| JRPP No: | 2010SYE044 |
| PROPOSED DEVELOPMENT: | Bethesda House and Stead House redevelopment - 80 Victoria Road & 12 Leicester Street, Marrickville |

Assessment Report and Recommendation

Image 11: Site plan

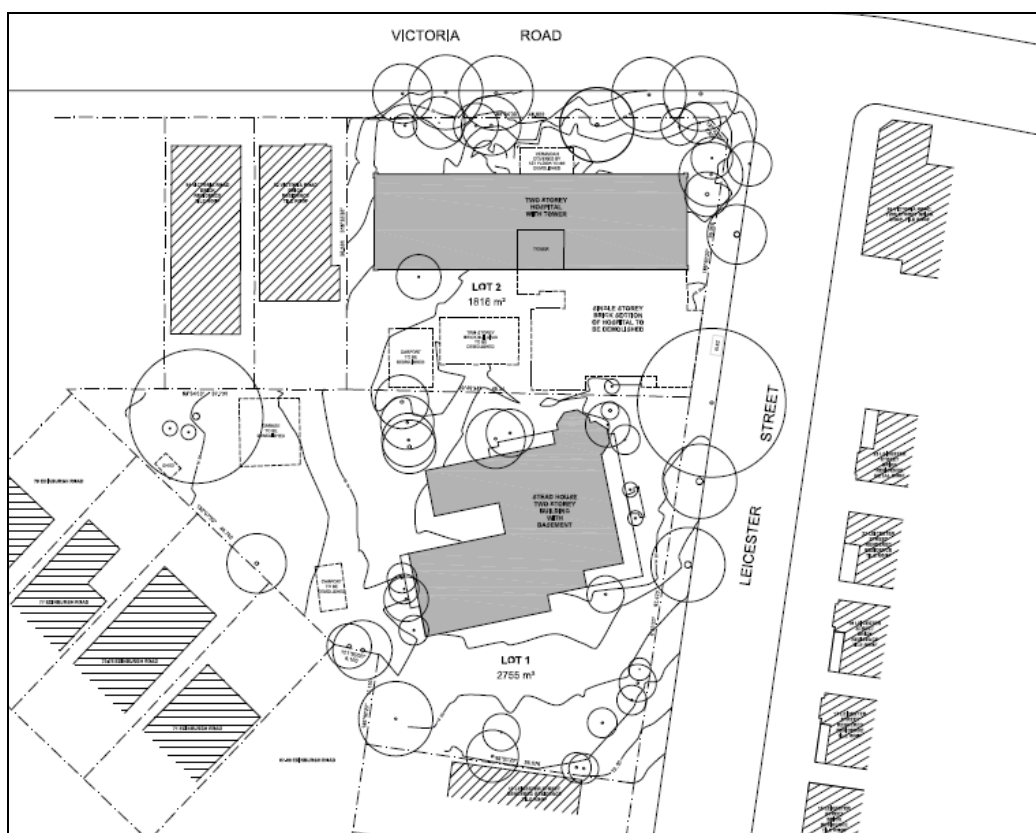
The site has been filled with buildings. There is no design consideration in their placement or shape, other than maximisation of building mass on the site. Site planning is therefore not sympathetic to the significant items. Additions of built form to Stead House, other than restoration cannot be supported as they are not proven to be necessary to the conservation of the item, in fact they are intrusive. The number of apartments on the site exceeds a comfortable amount by a total of 11 (2 in Block E, 2 in Block D, 3 in Block B, and 4 in Block C). The use of the semi submerged basement area as habitable rooms is not considered appropriate due to the scale of work involved, and the poor quality of the resulting spaces having limited light air and outlook, with the exception of the Media rooms, and Unit C1, bedroom 2.

The setting is very restricted by the proximity of other buildings, and the landscape plan is merely a conglomeration of leftover spaces with pathways through the middle. Hedging around both Leicester Street driveways will obscure safe viewing of the footpath. Pathways are only 1 metre wide – this is insufficient for adequate passing space for the high volume of residents.”

- Insufficient curtilage around Heritage Items, particularly Stead House (3 metre side setback for a length of 17 metres): by reducing the footprints of introduced buildings, and improving site planning, the setting of items could be significantly improved.

It is considered the proposed development scheme would adversely affect the amenity of the surrounding area. The applicant proposes the provision of two driveways off Leicester Street. Particular concern is raised with regard to the driveway located closest to 10 Leicester Street. The proposed driveway entry to the basement from this point would impact on the amenity of 10 Leicester Street. Furthermore, Marrickville Development Control Plan No. 35 - Urban Housing (Volume 2) prescribes that a minimum of 2 hours of solar access be maintained to principal living areas and principal area of open space. The shadow diagrams presented with the application tend to illustrate that solar access to the north facing windows along 10 Leicester Street have been compromised. Rooms to which these windows relate have not been identified. The provision of room use and elevational shadow diagrams including the provision of March/September shadows need to be provided to ascertain solar impacts to 10 Leicester Street.

is unacceptable. The plans shall be amended so that that there is only one vehicle access provided off Leicester Street. The design of the underground car parks shall also be amended to suit a single vehicular access.”

Image 17: Proposed elevations and section of Block A-B

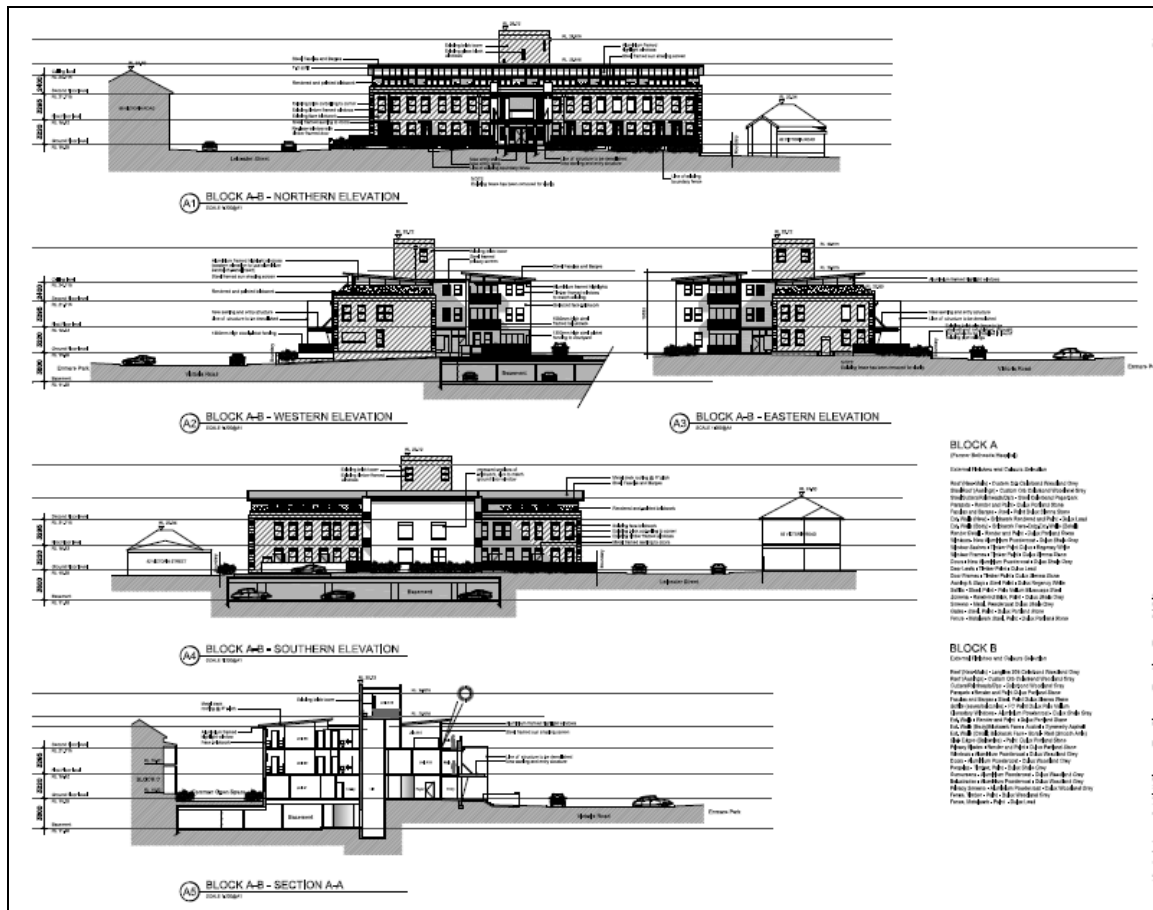
To this extent, concern is raised with proposed additions to Bethesda House. Bethesda House is currently a two (2) storey building and as part of the subject development it is proposed to add a third and to a lesser extent a fourth storey to the existing building. Furthermore, a three (3) storey extension is proposed at the rear of the existing building. Concern is raised with the size of this additional floor plate and the impact it will have on the general appearance of this heritage significant building and the streetscape generally. It is considered that if this additional level is to be supported as part of any development scheme on the site, it must be setback sufficiently from the outer edges of the existing building to ensure it is a recessive element that is somewhat screened by the parapet of the existing building when viewed from the surrounding streets. While it is noted that the additional floor is setback from the front façade, it is not setback from the side facades of existing building. Given the lack of such a setback, the upper level will be clearly visible when viewed from the public domain and this is not considered to be an appropriate response to the streetscape. The existing building is of a height, bulk and scale which exceeds that of its neighbours and given the limited development potential afforded by zoning provisions that apply to the subject site and the properties which surround the site, this is unlikely to change in the foreseeable future. As such, the proposed additional floor should be setback a sufficient distance from the outer edges of the existing building to reduce its visibility from both Victoria Road and Leicester Street thereby reducing the perceived bulk and scale of the overall development.

Bethesda House is currently a two (2) storey building and as part of the subject development it is proposed to add a third and to a lesser extent a fourth storey to the existing building. Furthermore, a three (3) storey extension is proposed at the rear of the existing building. Concern is raised with the size of this additional floor plate and the impact it will have on the general appearance of this heritage significant building and the streetscape generally. It is considered that the proposed additional level is not setback sufficiently from the outer edges of the existing building and would become a dominant element when viewed from the surrounding streets. Whilst it is noted that the additional floor is setback from the front façade, it is not setback from the side facades of existing building. Given the lack of such setback, it is considered that the upper level would be clearly visible when viewed from the public domain. This is not considered to be an appropriate response to the streetscape (reaching a height of 10.1 metres).

Whilst it is noted that the existing building is of a height, bulk and scale which exceeds that of its neighbours, given the limited development potential afforded by zoning provisions that apply to the subject site and the properties which surround the site, this is unlikely to change in the foreseeable future. The lack of a sufficient setback from the outer edges for the second floor of the existing building increases the proposal's visibility from both Victoria Road and Leicester Street and increases the perceived bulk and scale of the overall development. As such the increased height of Bethesda House is considered unsatisfactory.

Bethesda House..... The rear link should also be in contrasting materials to clearly differentiate the two buildings. Likewise the design of Block B should be more contemporary. Double hung windows are not necessary, as are the 'pretend' removed and bricked up windows on the south facing wall..... Block B does not provide sufficient contrast.....to Bethesda Hospital.
